**Survey of items**

## 94 Body noises

94-87051 Wind noises in area of window sill of rear door.

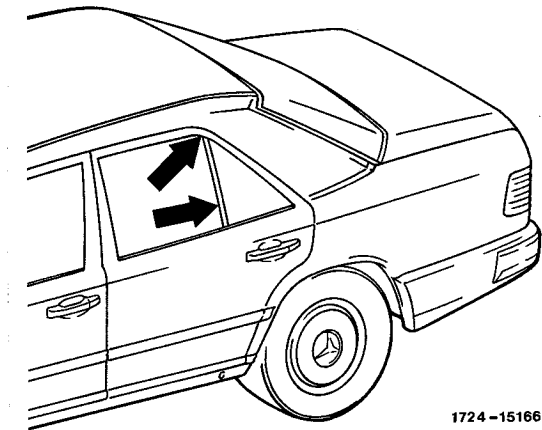
1. Window guide rail is insufficiently held in window sill.
2. Poor fit of window guide rail at top in corner of window sill.

1. Install modified window sill (with additional profile on the inside of the crank-operated window and on the outside of the quarter window.

2. Install modified window guide rail on rear door.

The modified window guide rail will be delivered carrying the same spare part number as before. It is recognized only by the modified angle at upper, rear corner. In removed condition, this angle should amount to approx. 130 degrees.

94-88101 Clicking noises in area of rear pillar between plastic molding and fender.

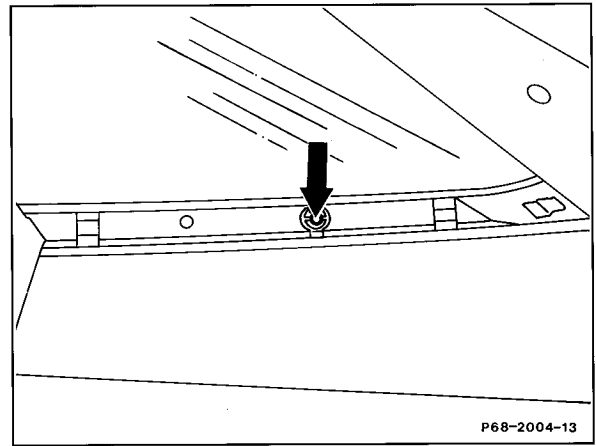
Bottom edge of plastic molding resting on rear fender.

Install rubber buffer, part no. 201 987 02 39, under plastic molding (arrow).
